NSW Energy Transition

Response to Draft Planning Guidelines

25 January 2024

Figure 2. Setback from sensitive receivers

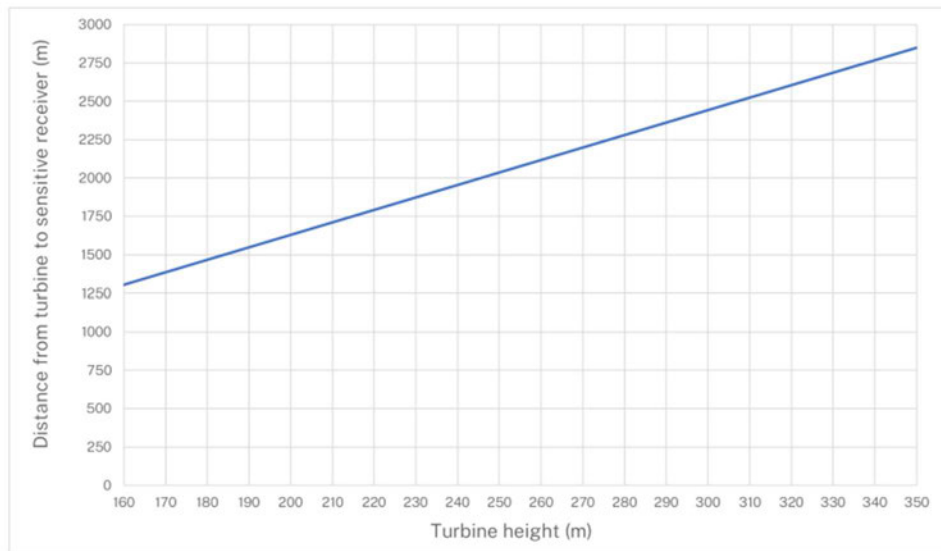
Burrendong SOS request that DPE provides references to the empirical evidence that the development of the Figure 2 diagram has been based on.

Figure 2 clearly does not align with the findings of Sullivan, et. al, (2012): Wind Turbine Visibility and Visual Impact Threshold Distances in Western Landscapes - a study that is referenced in the current NSW Visual Assessment Bulletin and which provides a strong supporting argument for a mandatory 6km minimum upfront setback of turbines to dwellings.

It begs the question, has the creation of Figure 2 solely been based on the pressure and wants of 100% profit-driven and predominantly foreign-owned multinational wind energy corporations, such as Ark Energy? Is this an independent, fair or just requirement? Will this requirement help to reduce the devastating adverse impacts of rural communities and landowners in this fast-paced transition to renewable energy?

Figure 2 and the proposed *optional* 2km setback from 250m high turbines does not take into account the heightened visual impact of e.g. 250m high turbines proposed on ridgelines that can tower up to and over 3/4km into the air (to their tip) above the relative ground level of sensitive receivers below. No amount of visual mitigation measures can screen views to the sky! – this is a devastating visual impact and requires a much greater setback than 2km. Figure 2 must be amended to require a greater setback that accounts for the overall height of turbines proposed on ridgelines above the relative level of surrounding sensitive receivers.

- **The 'red line' on Figure 7 should be the mandatory setback line (replacing that of 'Figure 2 – Setback from sensitive receivers');**
- **The blue line on Figure 7 should be the 'Other Public Viewpoints / Private Receivers' study area line; and**
- **There should be a new line added for 'Sensitive Public Viewpoints' that extends out to 25km for turbines 250m in height.**

Figure 6. Rule of thumb for measuring magnitude

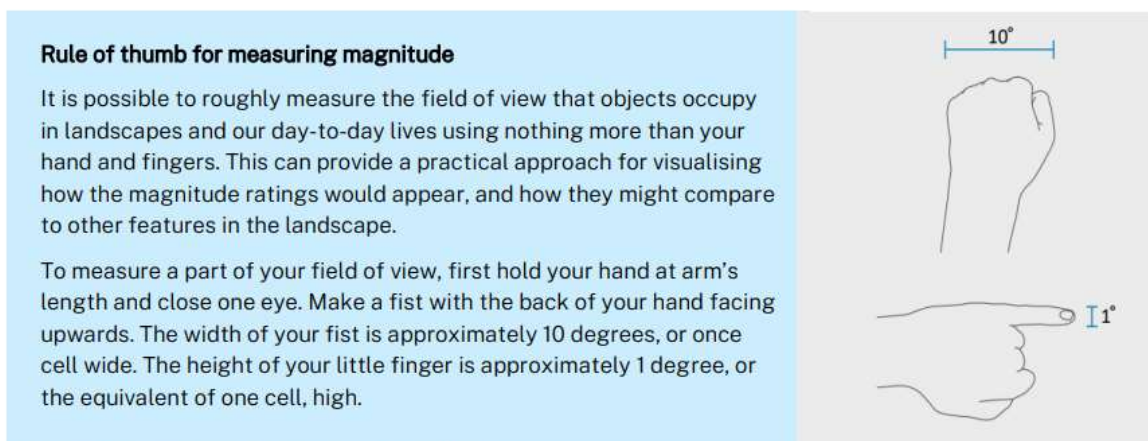
The suggestion that any turbines that would be less than 2 degrees in vertical field of view should not be counted when calculating magnitude is not supported by Burrendong SOS, especially taking into consideration cumulative visual impacts and the precedent set by **IT Power (Australia) Pty Ltd v Mid-Western Regional Council [2023] NSWLEC 1800**.

Figure 7. Extent of the scoping study area

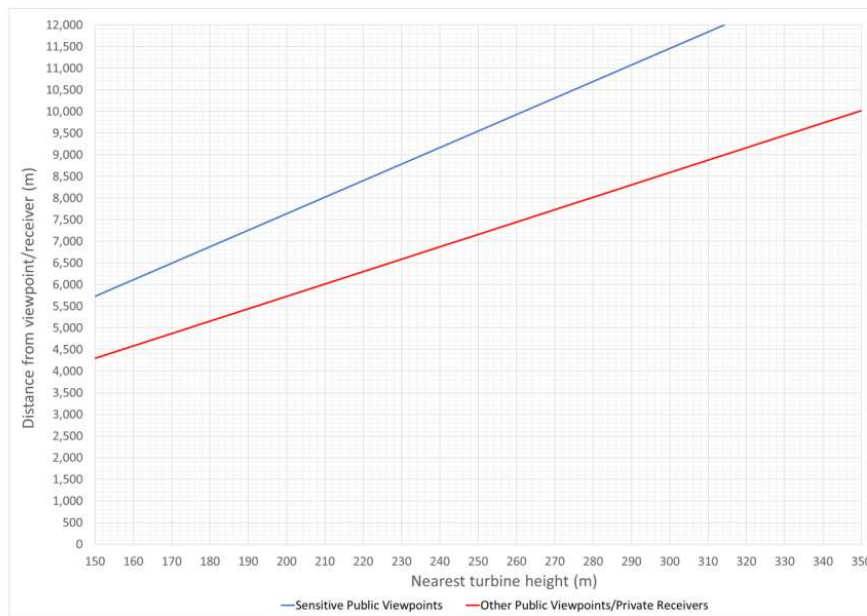
Could DPE please advise on what empirical evidence the ‘Figure 7 – Extent of the scoping study area’ diagram is based? Or is it just based on the current political vibe and corporate pressures?

Taking the above findings of Sullivan, et. Al, (2012) into consideration and the fact that for example, wind turbines located north-east of Wellington are clearly visible at over 30km from Wellington, on the major road from Molong, Burrendong SOS asserts that Figure 7 presents a gross underestimation of required study area boundaries.

- **The 'red line' on Figure 7 should be the mandatory setback line (replacing that of 'Figure 2 – Setback from sensitive receivers');**
- **The blue line on Figure 7 should be the 'Other Public Viewpoints / Private Receivers' study area line; and**
- **There should be a new line added for 'Sensitive Public Viewpoints' that extends out to 25km for turbines 250m in height.**

Figure 13. Visual reference for considering existing vegetation screening

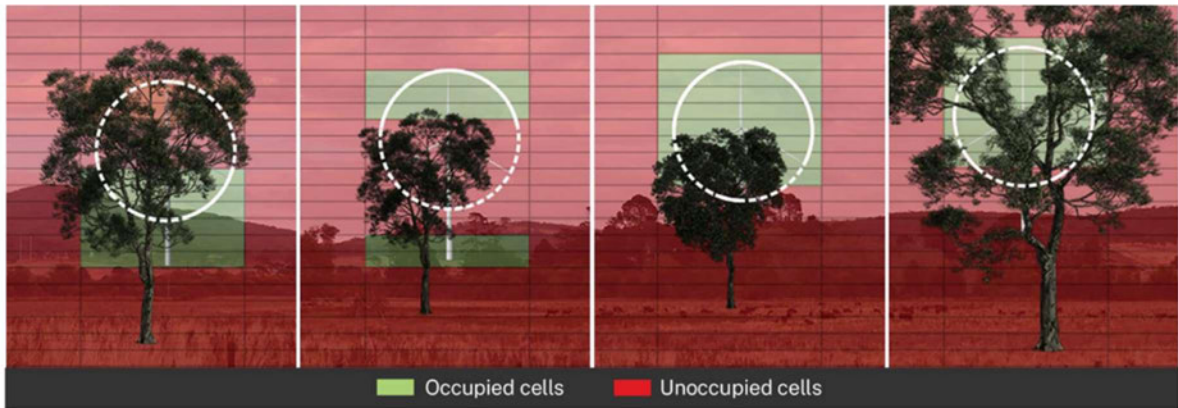
We disagree with this section indicating a single existing tree to be sufficient for screening purposes and reducing a residence's visual impact:

In line with this, Figure 13 needs to be amended to a view of multiple trees, rather than a solitary specimen.

Figure 3: Land use impacts of undergrounding post laying underground cables

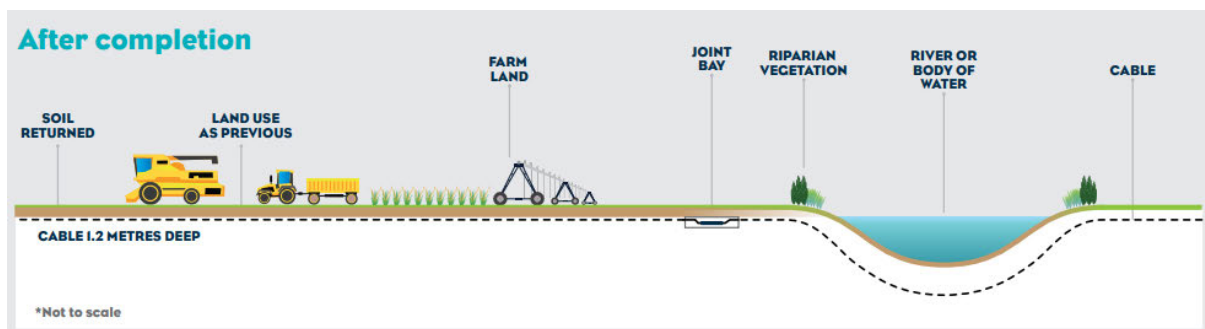
Contrary to the statement ‘underground transmission infrastructure, typically requires removal of1-2 metres of the ground surface’ Figure 3 shows cables are buried at 1.2m.

As shown in Figure 3 above, agriculture can be carried out as usual above underground cables.

Figure 2: Impacts of concern from overhead transmission lines and underground cables

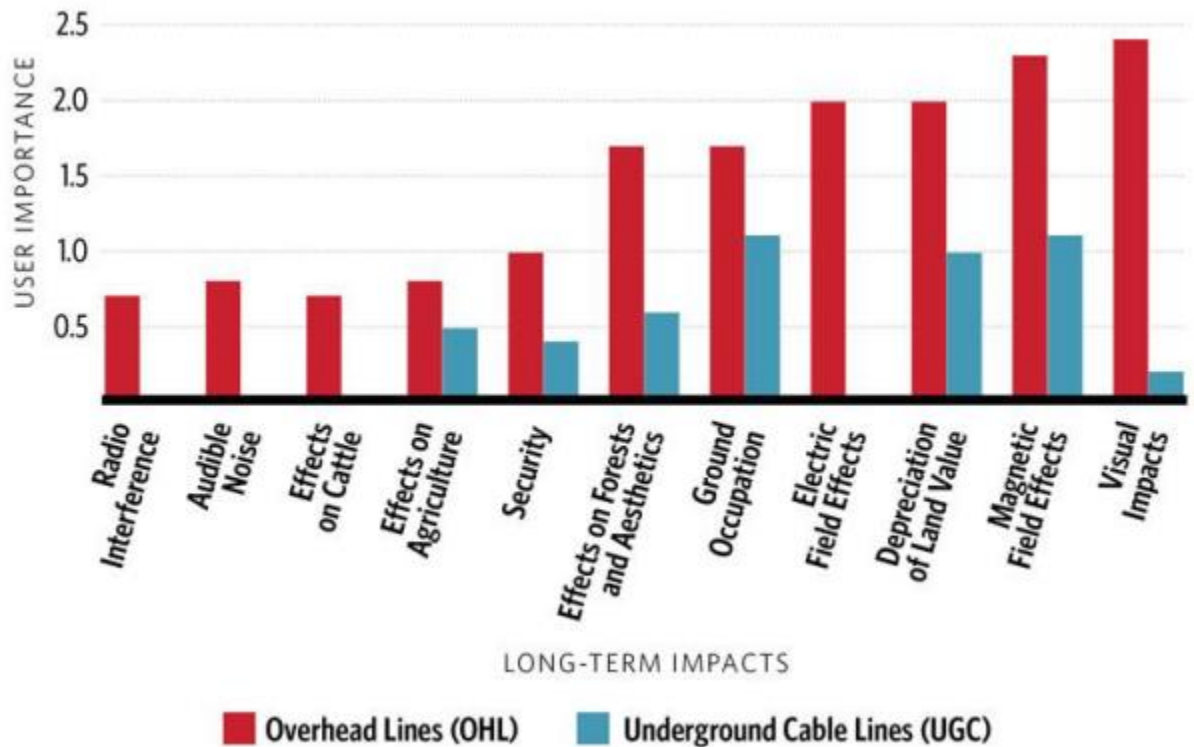
In all cases overhead lines have greater negative impacts than underground cables. One factor not assessed for ‘user importance’, in the study above, is “bushfire risk”, which is a major concern in regional areas of Australia. Underground cables provide an important benefit of eliminating the risk of starting and controlling bushfires.
